## REVIEW OF GROUND ISSUES

<b>Job No.</b>	3435	<b>Site area/ha</b>	8.3	
<b>Client:</b>	Harron Homes	<b>NGR:</b>	SE 174 173	
<b>Site:</b>	Crossley Lane, Dalton	<b>Nearest postcode:</b>	HD5 0QP

**Introduction.** It is understood that Harron Homes are considering acquisition of land at Crossley Lane, Dalton with a view to redevelopment with housing. Harron have provided Lithos with copies of the following:

**PRELIMINARY ZONING PLAN - PILED FOUNDATIONS**

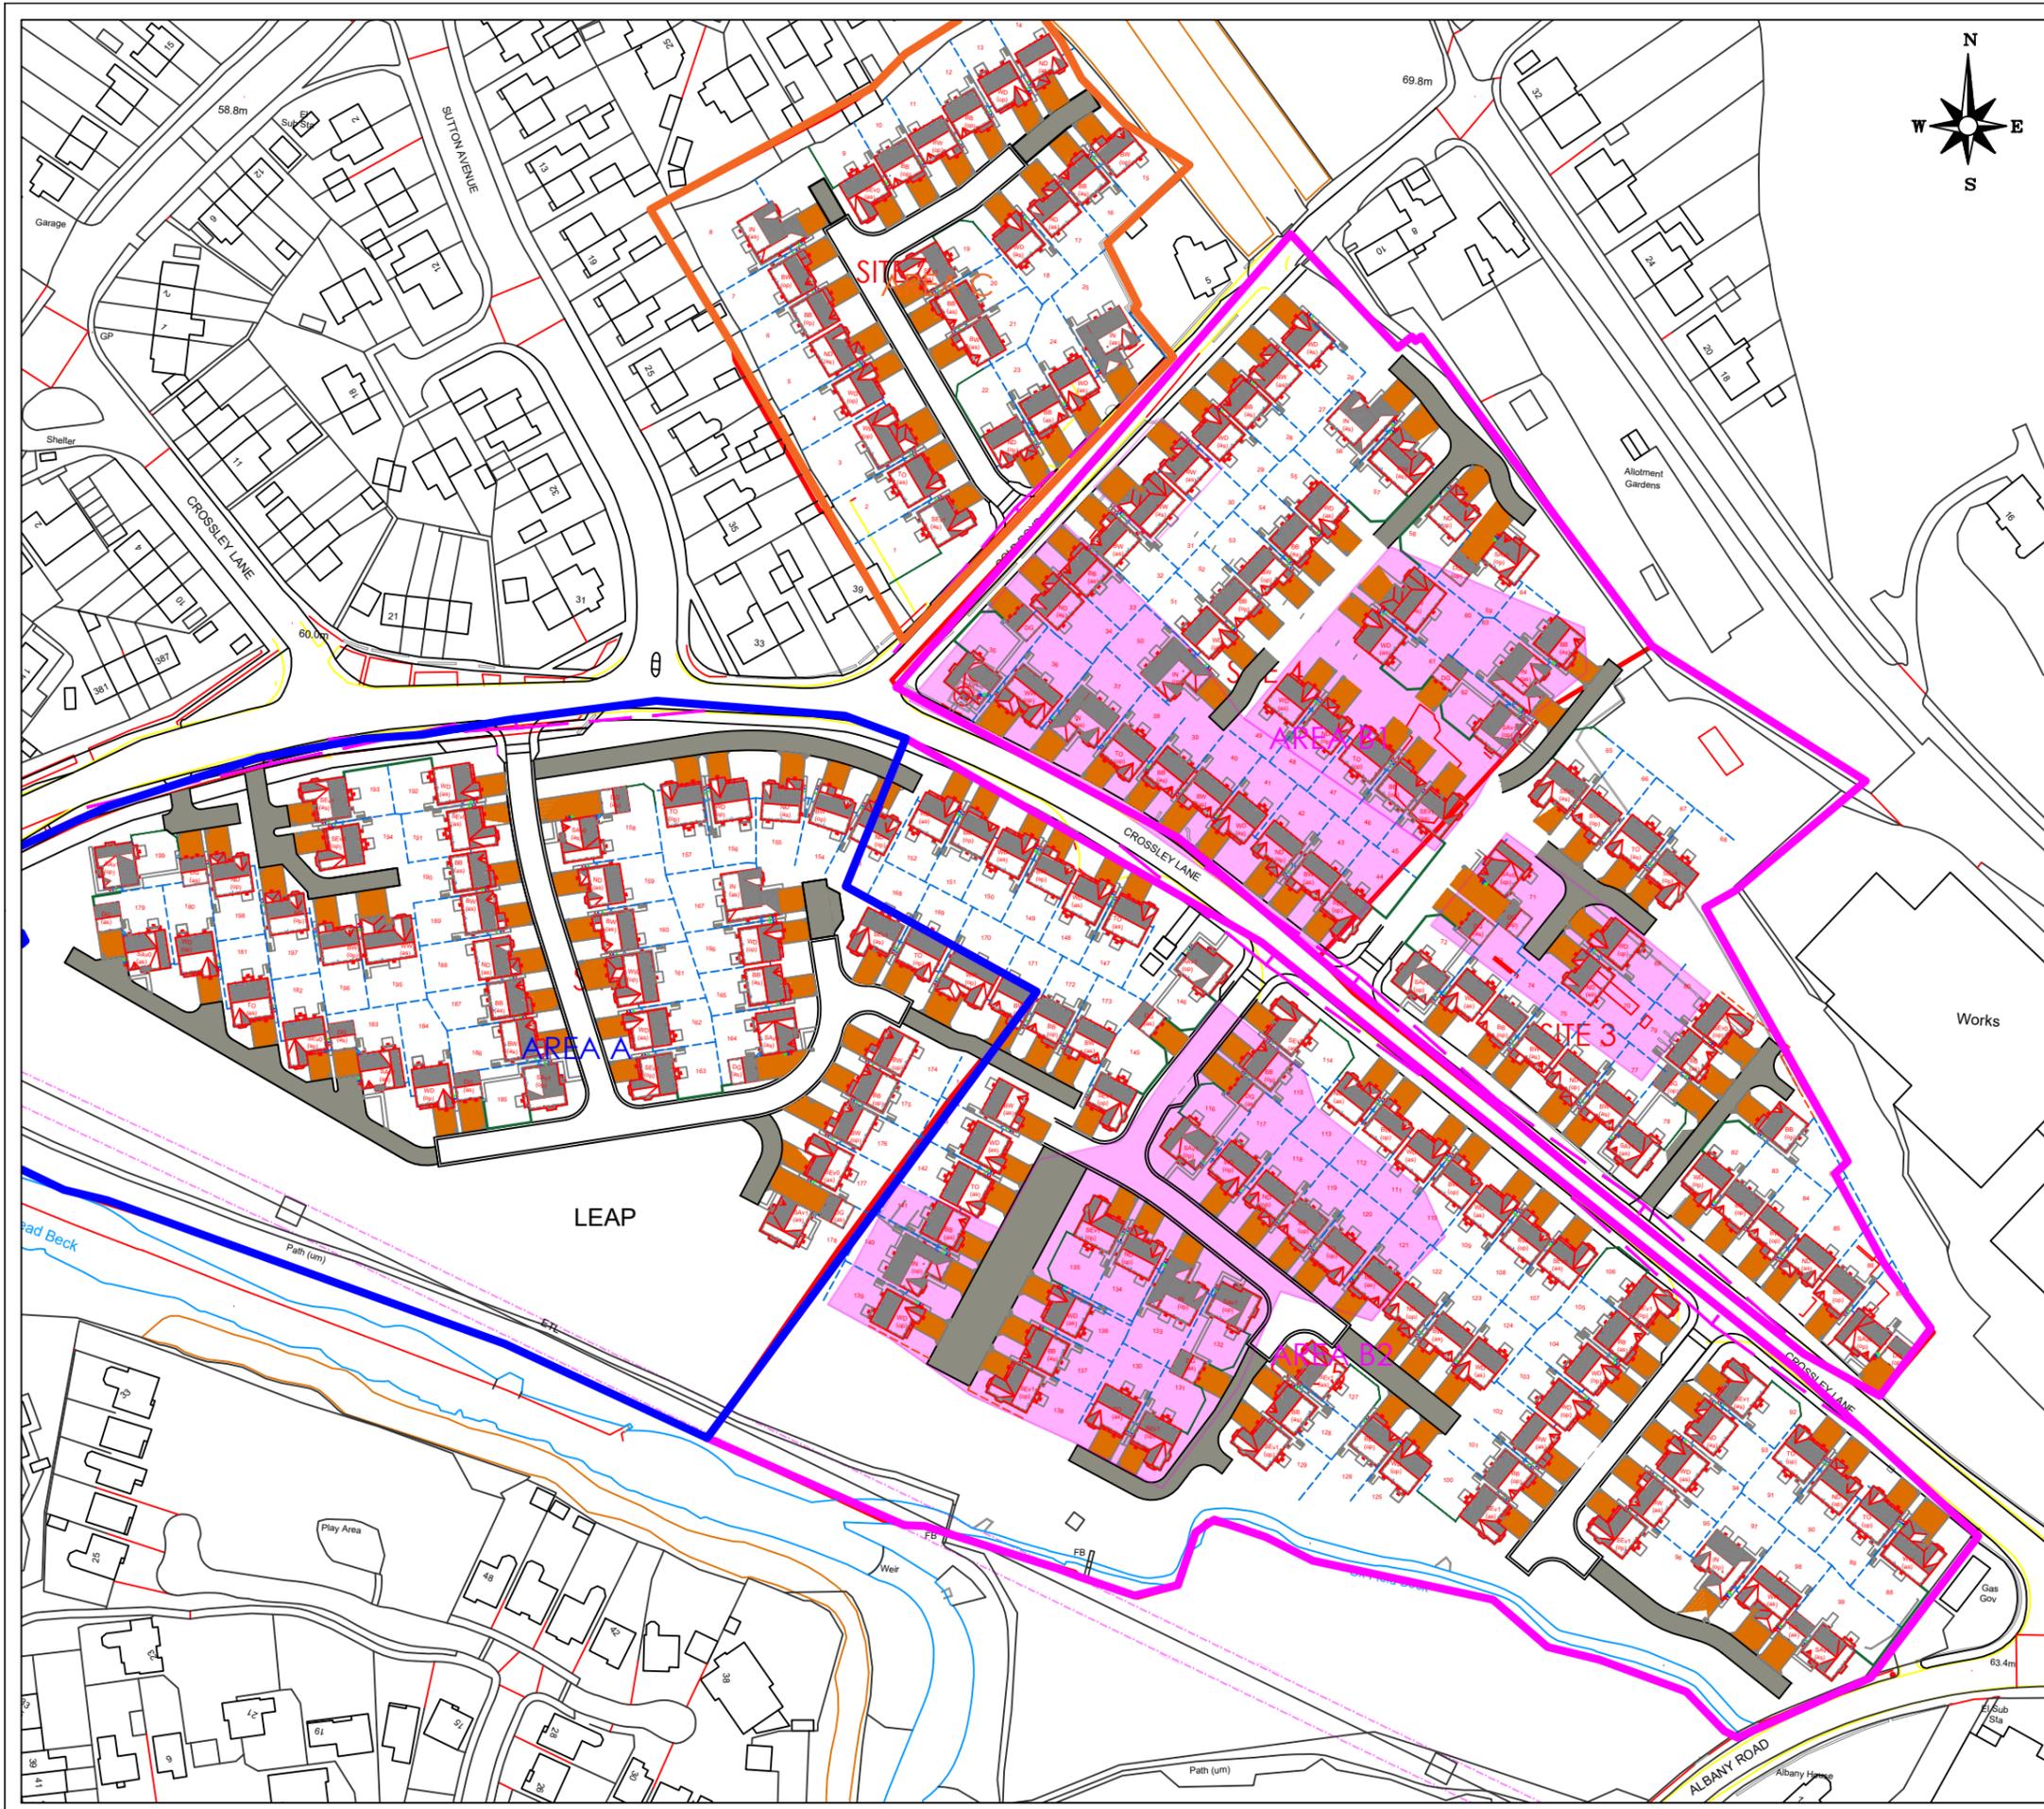
Piled foundations are recommended by ARP in the south of Site 1, the majority of Site 4 and all of Site 5 where competent strata are at significant depth (c. 4m) and/or where the nature of shallow natural strata is highly variable.

That said, some preliminary recommendations can be given based on the data available from ARP's investigation. An approximate zoning plan showing areas likely to require piling has been produced by Lithos (see Drawing 3435/2) based on the ground conditions reported by ARP.

**PILED FOUNDATIONS**  
 (made ground and/or soft/loose ground to >2.5m)  
 Elsewhere, strip/trench fill foundations potentially feasible depending on supplementary site investigation

KEY FEATURES & REMEDIATION ZONES

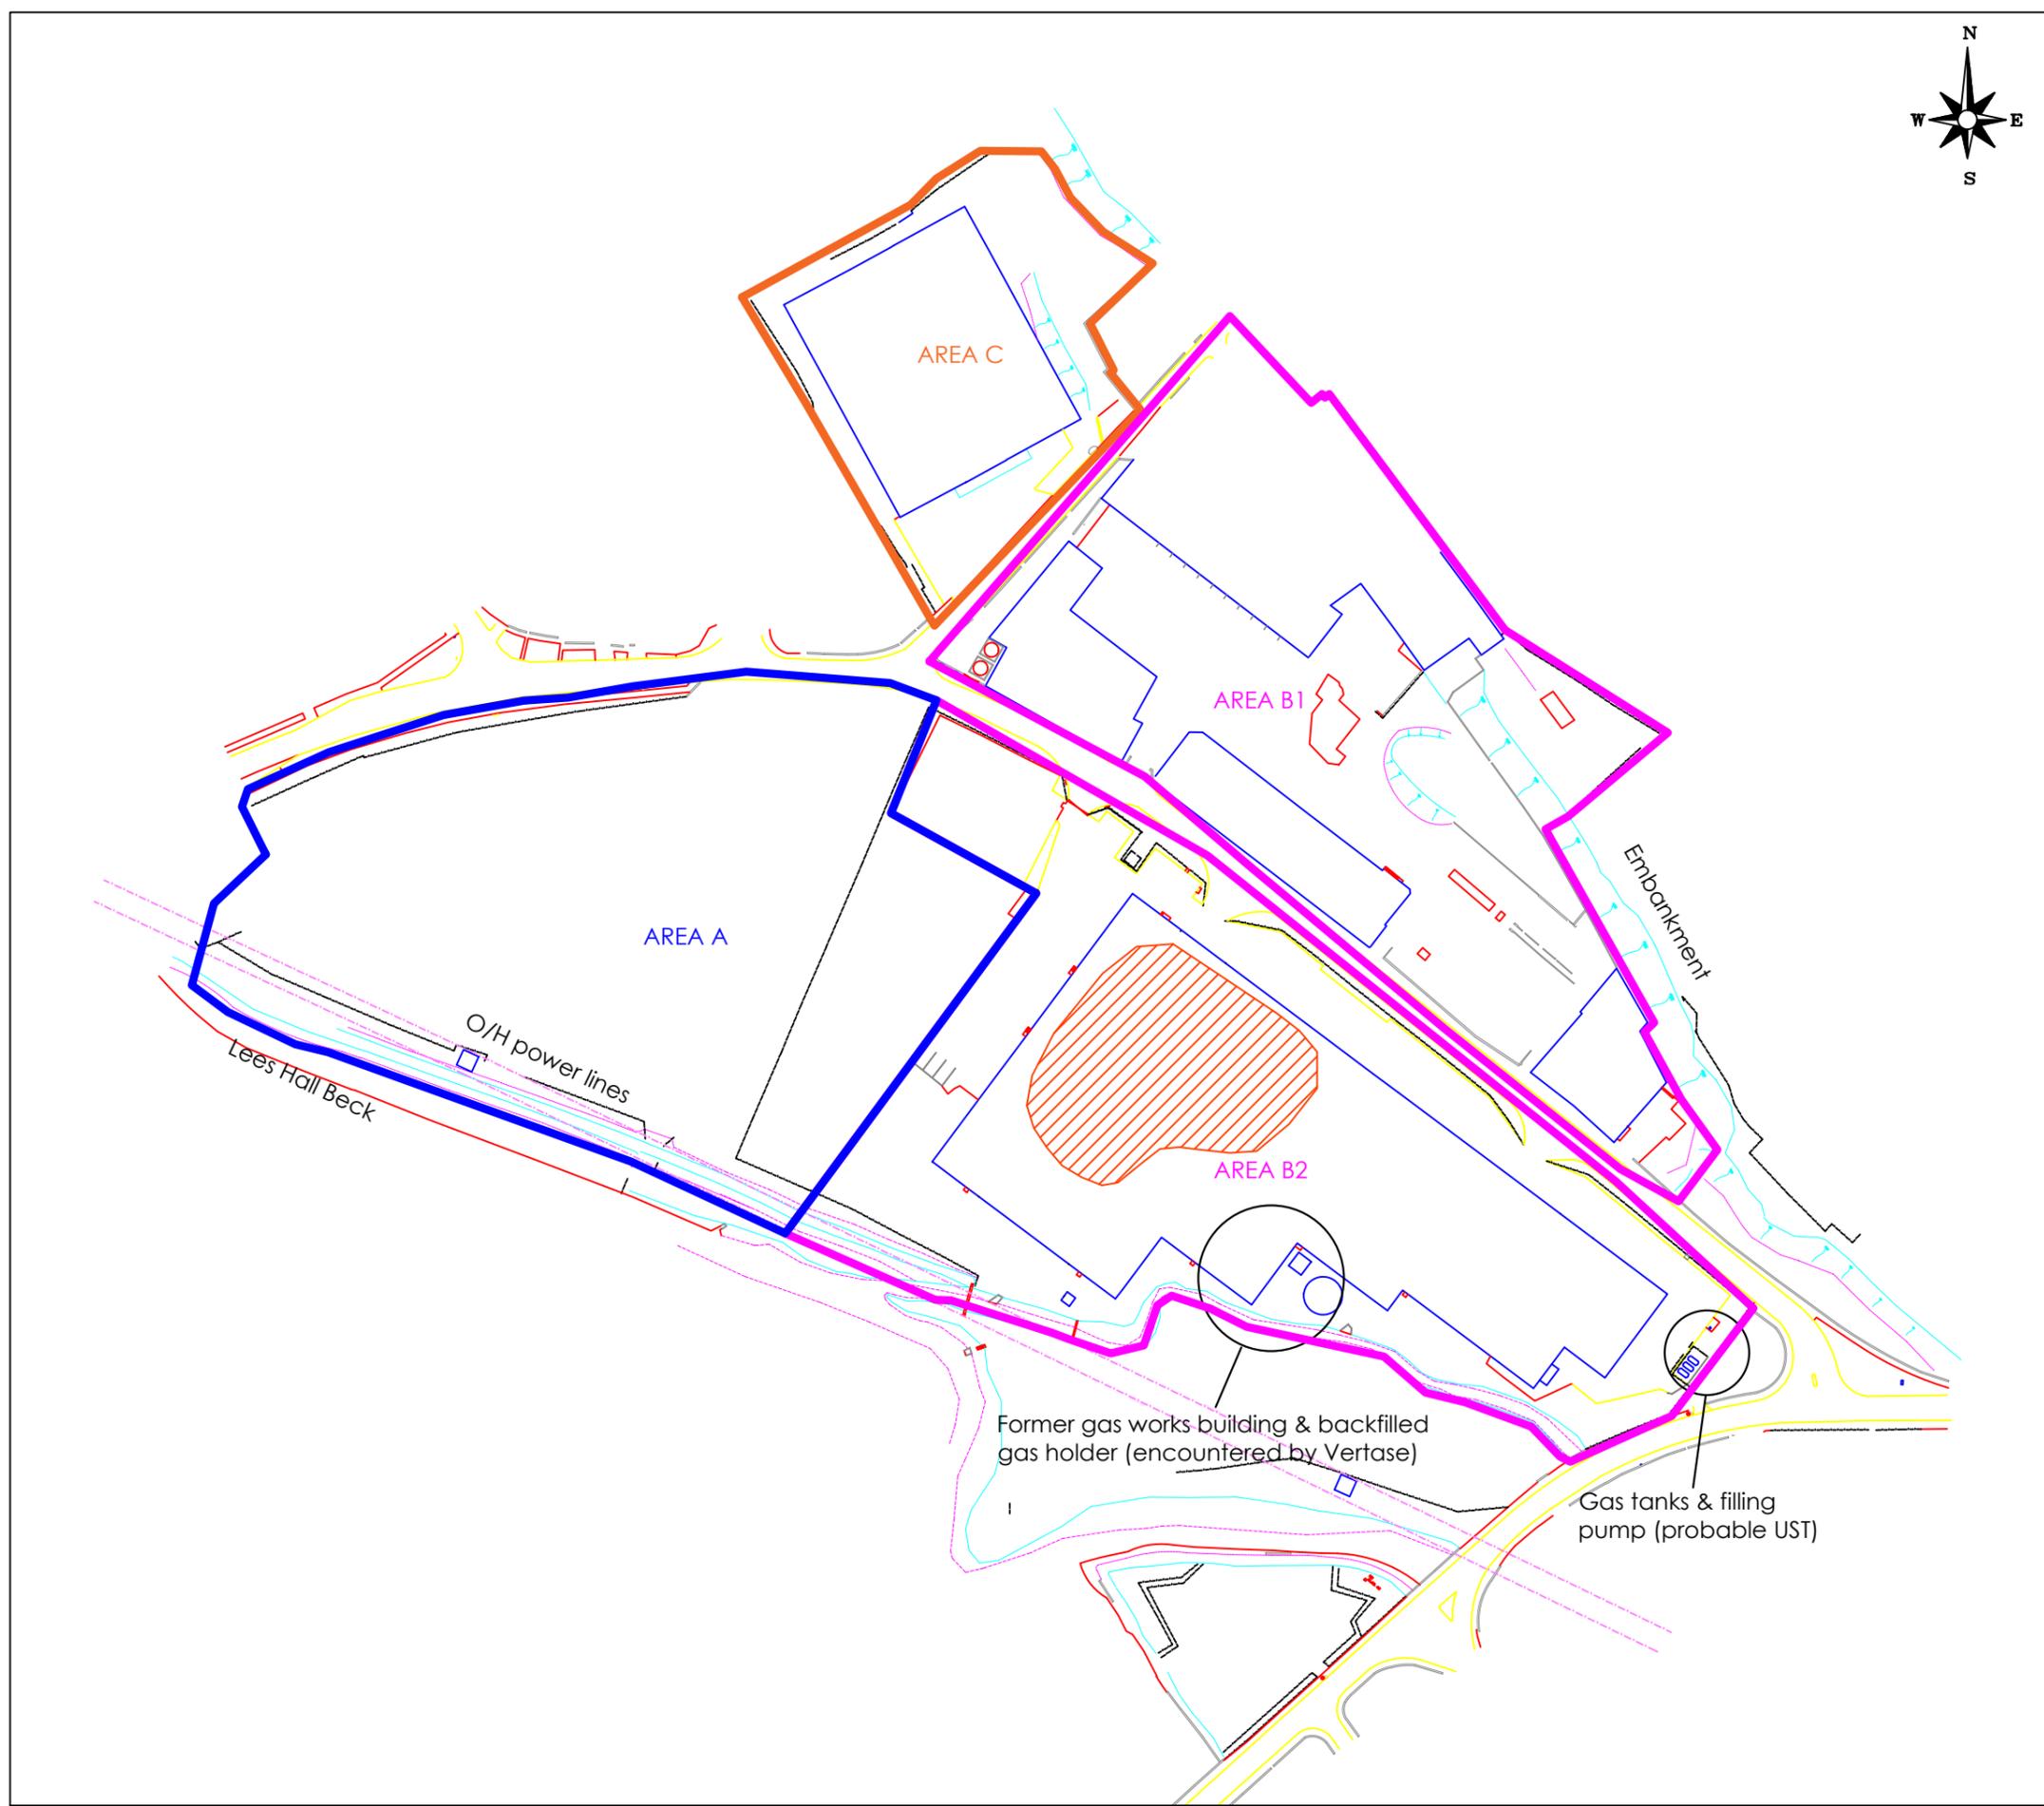
Instead of dividing the site into Sites 1 to 5 (as per ARP's reports), the following zoning of the site would be more appropriate when assessing contamination risks and remediation proposals (as shown on Drawing 3435/3):

- **Area A** - Greenfield area in the south-west (Site 1): No significant made ground or contamination encountered and no remediation required
- **Areas B1 & B2** - Former Minerva Works gas works and bleach & dye works (Sites 3, 4 & 5): Contamination includes heavy metals, PAH, VOCs and asbestos. 600mm clean soil cover and 100mm hard dig later required in garden/landscaped areas. Excavation and treatment/disposal of contamination hotspots.
- **Area C** - Former industrial building in the north-west (Site 2): Some (relatively minor) arsenic and PAH contamination. 600mm clean soil cover required in garden/landscaped areas.

- AREA A - No remediation required
- AREA B - 600mm soil cover and 100mm hard-dig layer
- AREA C - 600mm clean soil cover
- HYDROCARBON HOTSPOT - Grossly contaminated soils encountered by ARP
